DEVELOPMENT REVIEW BOARD  
SUPPLEMENTAL SUBMITTAL

PROJECT NO. PR-2018-001284  
Application No. SI-2021-01962

**Re:** Markana Uptown Site Plan Amendment DRB Comment Responses (PR-2018-001284)

This memo outlines the responses and changes made to the site plan for the proposed addition of a 103-space temporary parking lot based on the comments received and reviewed at the December 15, 2021 DRB meeting.

**A1.10**

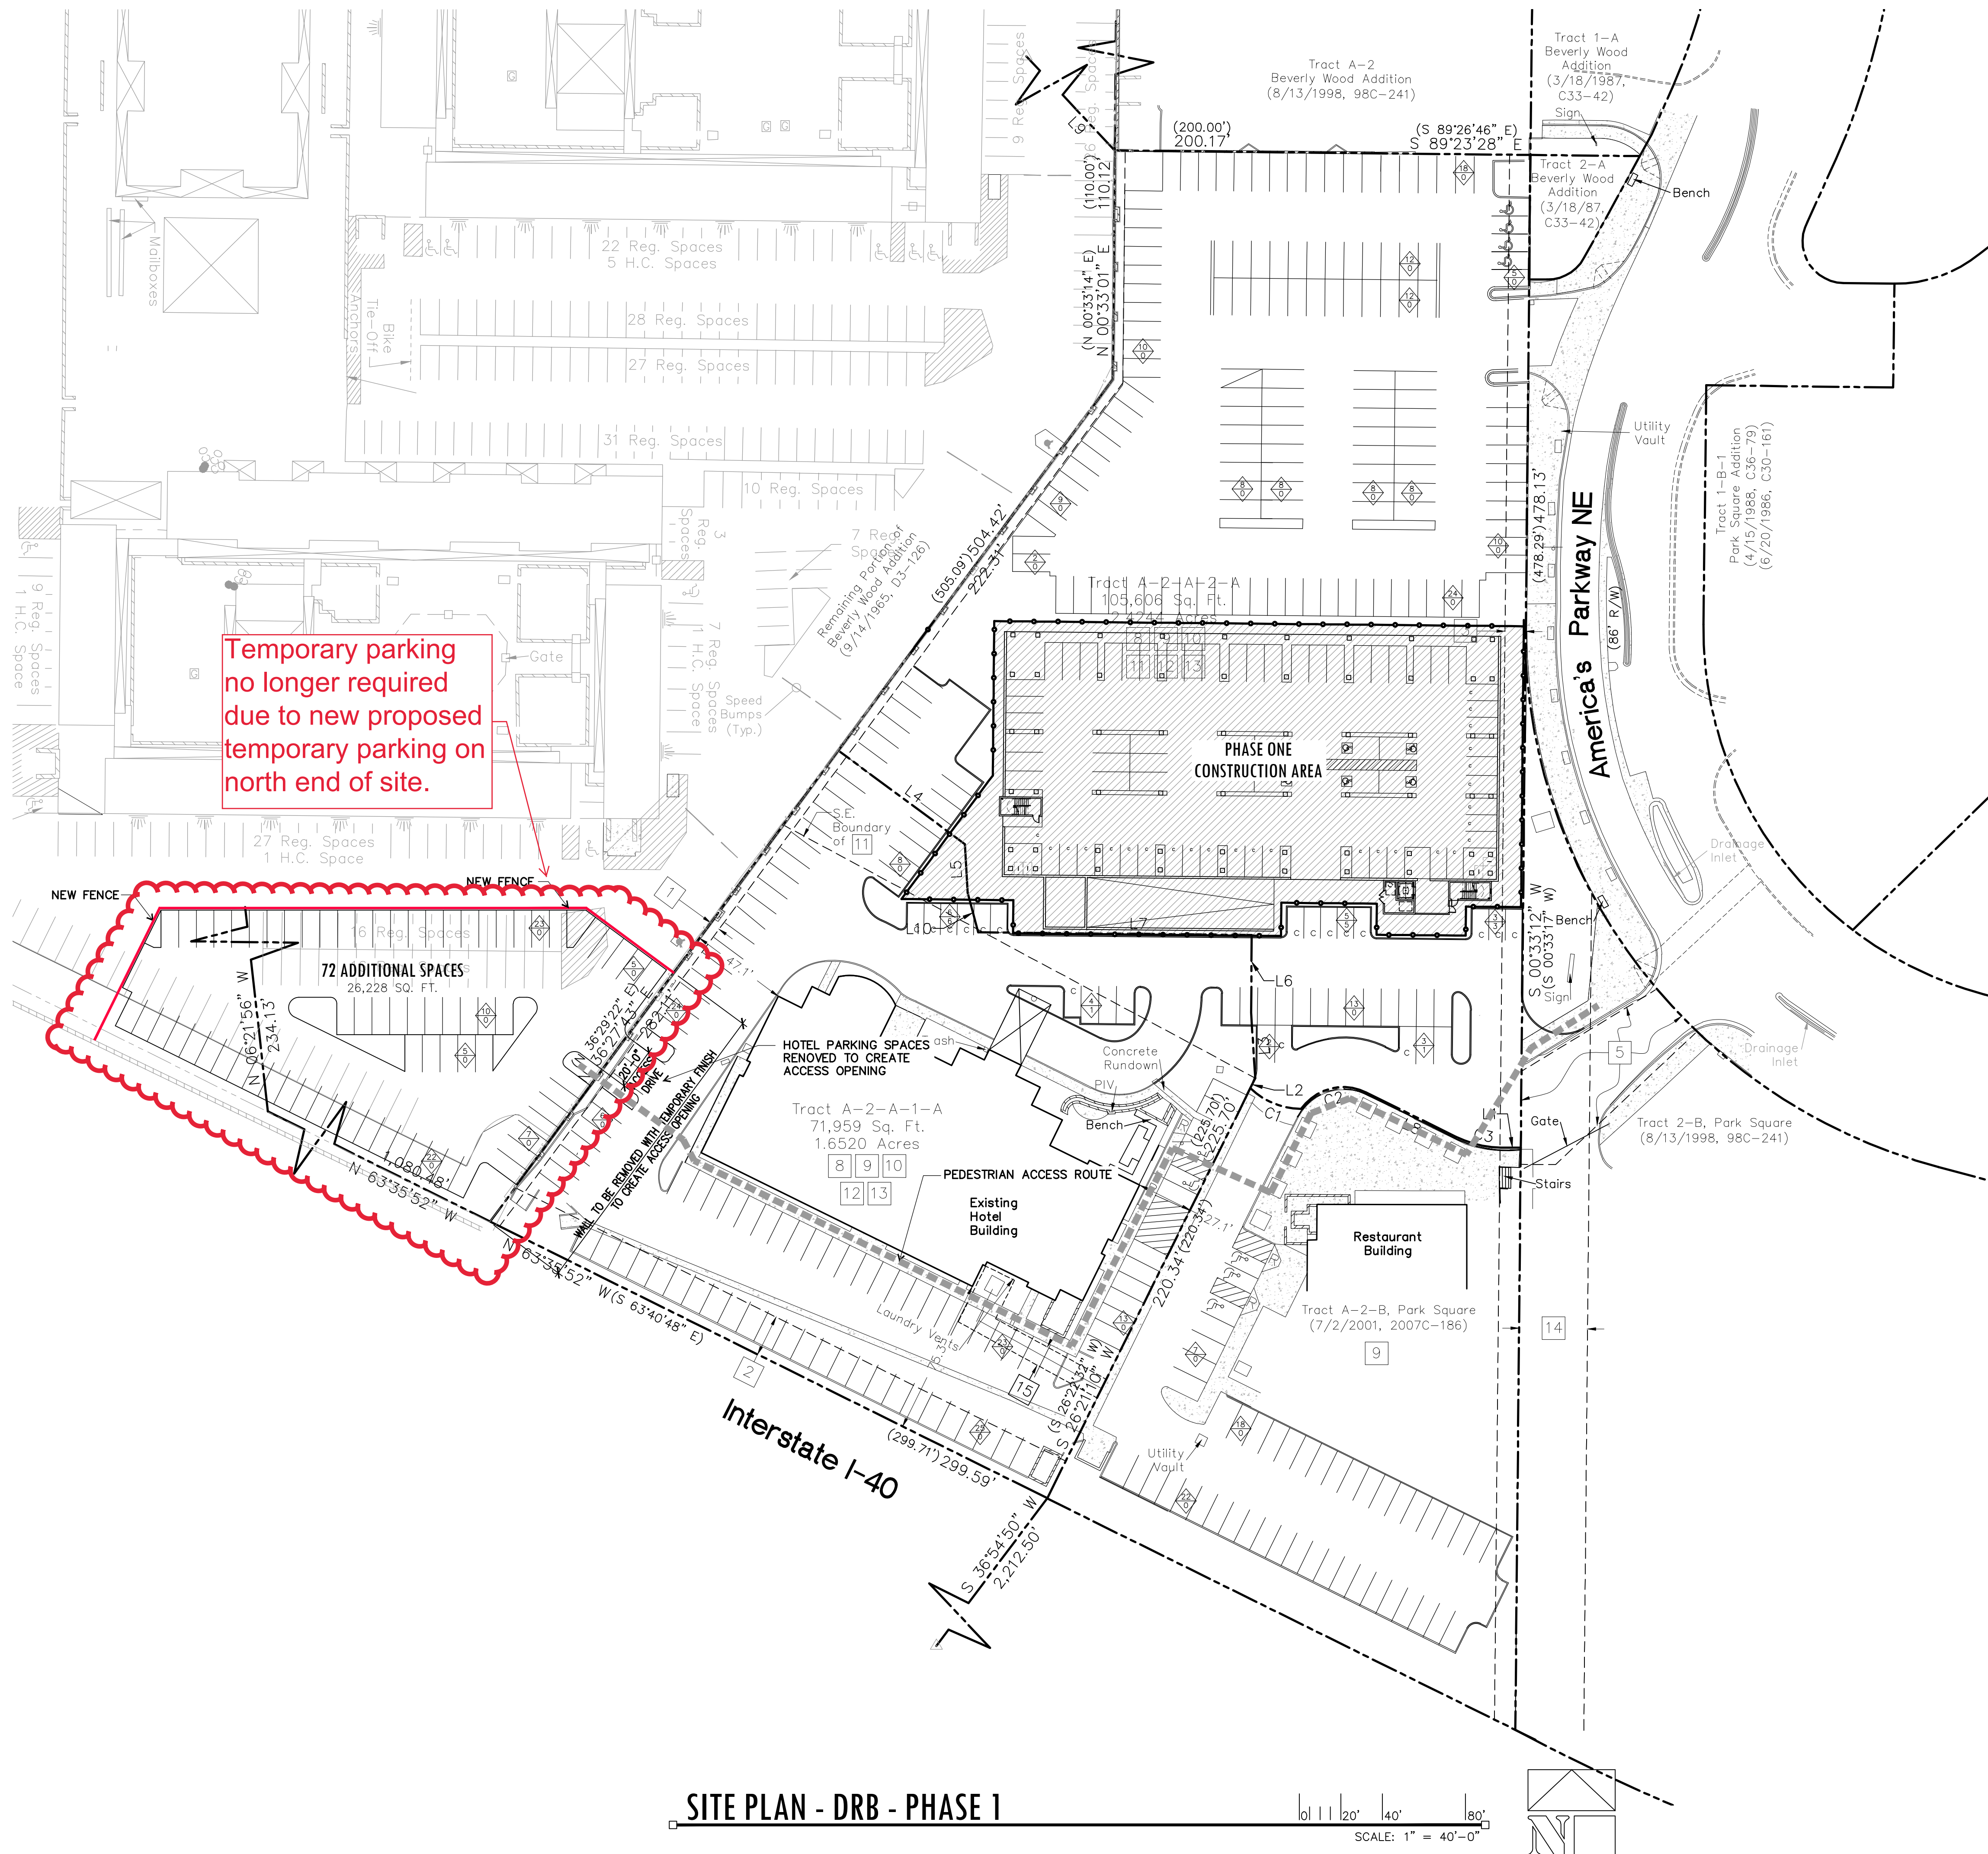
1. Per DPM, a 6 ft. wide ADA accessible pedestrian pathway is required from the ADA parking stall access aisles to the building entrances. Please clearly show this pathway and provide ramp and crosswalk details. ADA accessible pedestrian pathway should not be placed behind parking space or adjacent to a vehicular way. Vehicle and pedestrian/wheel chair conflicts should be avoided as much as possible.
  - *The Architect has added or clarified these paths on the site plan, where necessary.*
2. Curbing should be installed to delineate landscape, parking, and pedestrian ways and identify points of access. Please call out detail and location of all barrier curb. (Particularly for the

parking lot islands, curbed landscaped islands should be used as opposed to striped islands in order to separate traffic flow from parked cars. Follow DPM requirements for dimensioning and radii.

3. Call out all paved surfaces for each parking lot segment.
    - *Additional paving keynotes have been added to the plans.*
  4. ADA curb ramps must be called out with a keyed note on the plan; reference the details on the detail sheet according to the type of ramp needed.

6. Provide existing driveway entrance width for all driveways.
    - *Dimensions have been added for all driveway widths.*
  7. Provide all parking calculations, including those for ADA parking. It seems that the number of ADA parking spaces provided is less than what is required. Please revise the site plan VS building floor plan P1 as necessary. (sheet A3. 11)

8. Include necessary van accessible parking spaces and mark these on the plan with a minimum 8-foot wide dimension.
    - *Van spaces have been noted on the plans. As allowed, these spaces are 11 feet wide with a 5-foot aisle for a total of 16 feet.*

9. All compact parking spaces shall be marked as “Compact” in back. Note the maximum compact space parking requirement, and include these in the parking calculations.

- *The compact spaces have been marked and noted with keynote 4. A typical detail is provided with dimensions.*
  10. Include motorcycle parking signage and mark “MC” in the back of the parking space.

- *Motorcycle spaces have been marked and noted with keynote 16.*
  11. Include the required note for violators to be towed on handicapped parking sign.

14. For the clear sight triangles, use criteria for intersection sight distance. Incorporate onto site plan and landscaping plan.
  - *Updated clear sight triangles have been provided on the site plan and landscape plan.*
15. Bicycle parking requirements need to be included to check against number of spaces required. Provide dimensioning for overall bicycle parking areas.
  - *Bicycle parking requirements are listed in the parking table, and an associated detail shows required dimensioning.*

- *Additional notes have been added for curbing locations. Since the parking lot is intended to be temporary in nature, the Applicant requests that the islands within this parking area are allowed to be striped.*

- *The temporary parking has been added to the provided parking totals. ADA space locations throughout the site have been clarified with the current parking structure floor plans to show compliance with the requirements.*

- *EV charging station requirements are listed in the parking table with 11 required and 14 provided. Locations for these stations have been added to the site plan.*
